TECHNICAL EVALUATION REPORT

INSERVICE INSPECTION OF WATER CONTROL STRUCTURES

YANKEE ROWE NUCLEAR POWER STATION

July 15, 1982

Figure 1. General Site Feature Map

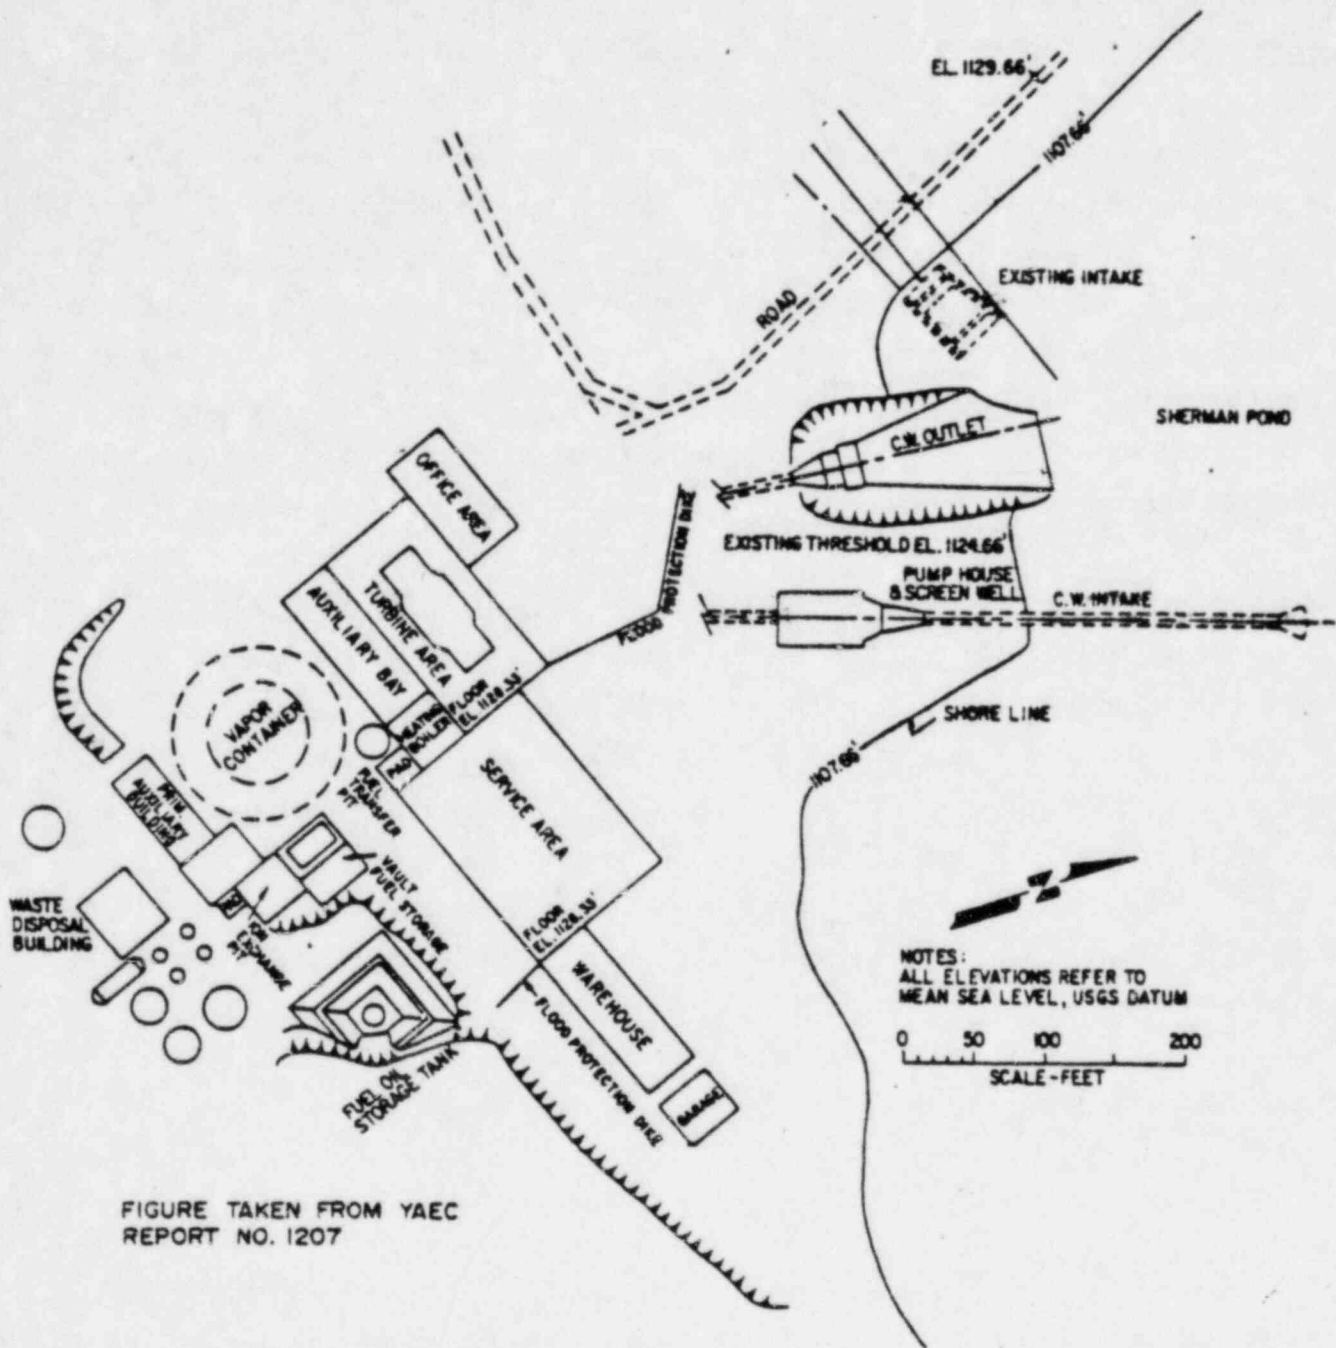
The Sherman Dam is identified by the Licensee as a water control structure at the Yankee Rowe plant. Its function is to impound the ultimate heat sink (UHS). The Licensee did not identify Harriman Dam as a flood control structure, even though its failure would cause flooding of the site [10]. The Licensee states that Sherman Dam is licensed and regulated by the Federal Energy Regulatory Commission (FERC) and that FERC maintains a formal inspection program which includes inspection reports [2]. The Licensee concludes that FERC's inspection program precludes the necessity of including Sherman Dam in this inspection program for the Yankee Rowe plant.

Both Harriman and Sherman Dams are safety-related water control structures, albeit for different reasons. Harriman Dam protects the site from the hazards of flooding caused by intense precipitation (probable maximum precipitation [PMP]) in the Deerfield River Basin (see SEP Topic II-3.B) and rapid discharge of Harriman Reservoir, while Sherman Dam impounds the ultimate heat sink (see SEP Topic II-3.C). Neither of these dams, however, falls under the strict interpretation of Regulatory Guide 1.127, Section C, which states "this guide applies only to water-control structures specifically built [underline added] for use in conjunction with a nuclear power plant and whose failure could cause radiological consequences adversely affecting the public health and safety." However, it is apparent that the intent of Regulatory Guide 1.127 is to include both of these dams since failure of either dam will result in unacceptable consequences to the site. In the case of Harriman Dam, a failure during full pool conditions would cause significant flooding of the site (see SEP Topic II-4.E, Dam Integrity), or a failure of the dam during intense precipitation in the basin (PMP) would result in flooding of the site (see SEP Topic II-3.B). In the case of Sherman Dam, failure would result in a loss of ultimate heat sink (see SEP Topic II-3.C). It is this reviewer's understanding that the nature and source of the ultimate heat sink at the site will be changed in the near future to a source independent of Sherman Reservoir. However, at present, according to the Licensee's submittal of SEP Topic III-3.C, Sherman Dam is a water control structure which falls under the requirements of Regulatory Guide 1.127. Therefore, the inspection programs conducted at both Sherman Dam and Harriman Dam should be included as components of the formal inservice inspection program at the Yankee Rowe plant.

The Licensee did not identify Harriman Dam as an essential flood protection structure. Harriman Dam is an essential flood protection structure and should be a component of the Licensee's future formalized inspection program.
